City of Portland, Maine - Building or Use Permit Application 389 Congress Street, 04101, Tel: (207) 874-8703, FAX: 874-8716

Location of Construction: 109 Huntington Ave		Owner: Susan M. Forbes	Phone: 797-0637	Permit No: 990317
Owner Address: SAA	Lessee/Buyer's Name:	Phone:	BusinessName:	<div style="border: 2px solid black; padding: 5px; text-align: center;"> PERMIT ISSUED Permit Issued: <div style="border: 1px solid black; padding: 5px; margin: 5px 0;"> APR 12 1999 </div> CITY OF PORTLAND </div>
Contractor Name: Aqua Pool	Address:	Phone:		
Past Use: 1-family	Proposed Use: Same w/pool	COST OF WORK: \$ 15,800	PERMIT FEE: \$ 100.00	
		FIRE DEPT. <input type="checkbox"/> Approved <input type="checkbox"/> Denied	INSPECTION: POOL Use Group: Type: BOCA 96	Zone: CBL: 410-F-021
Proposed Project Description: Install inground pool		PEDESTRIAN ACTIVITIES DISTRICT (P.A.D.) Action: <input type="checkbox"/> Approved <input type="checkbox"/> Approved with Conditions <input type="checkbox"/> Denied		Zoning Approval: 4/9/99 Special Zone or Reviews: <input type="checkbox"/> Shoreland <input type="checkbox"/> Wetland <input type="checkbox"/> Flood Zone <input type="checkbox"/> Subdivision <input type

18' x 36'
Steel reinforced Gunite swimming pool
depth to be 3 1/2 ft. to 7 ft
6" Frost Proof tile, white marble interior
finish.

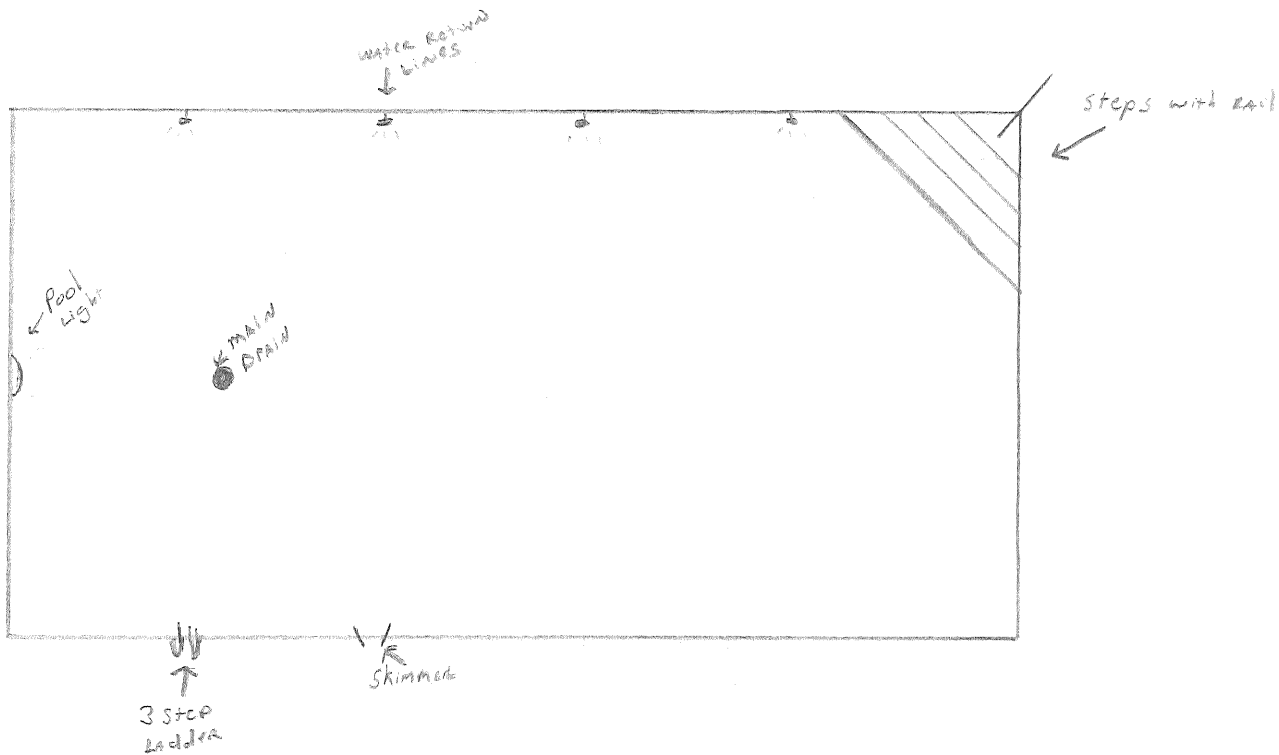
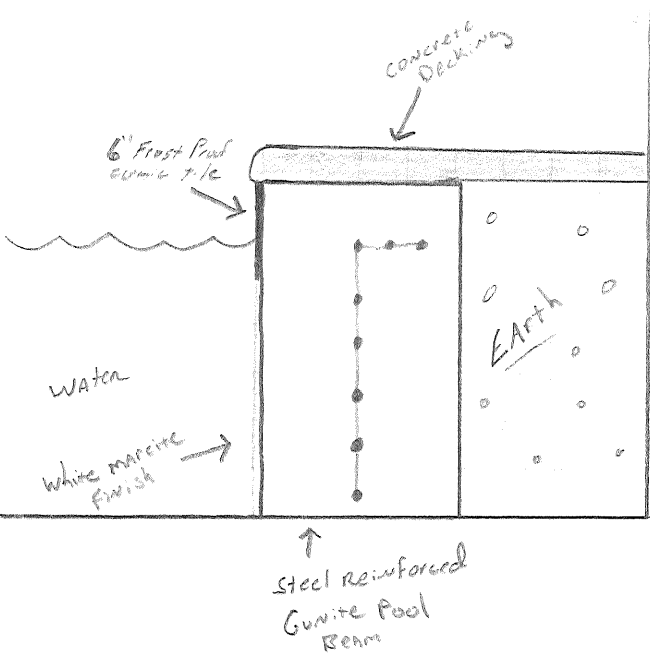
4-27-99- Pool extends into 25' Buffer also - only 9' 1/2" from house on inside corner - notified owner -

4/30/99 Note from Rick Knowland/Alex J. has determined that pool is NOT a structure & can extend into Buffer - there is still a ? Re: 10' Setbacks - owner will have a surveyor verify lines B-4 proceed by (JK)

7-16-99- Called owner. Pool appears to be complete and we still need SURVEYOR to verify lines. Told owner we need this ASAP. Also, no electrical permit was pulled for
